- Subject** ▶ Change of Cord Guard, Handle and Handle Cover
- For Models** ▶ HR5001C
- Country** ▶ All countries
- Description** ▶ Cord Guard, Handle and Handle Cover have been changed as illustrated below for further improvement in durability of Power Supply Cord and Cord Guard.

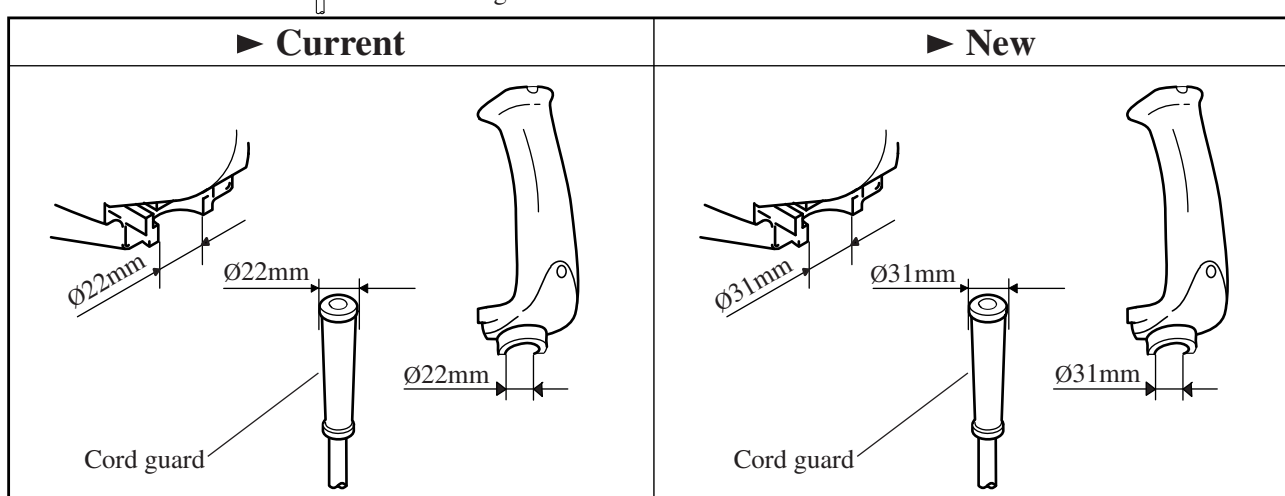
- 1) Cord Guard:  
Replaced by the one with larger neck.
- 2) Handle/Handle Complete and Handle Cover:  
Encircled places has been modified to accept the new Cord Guard.
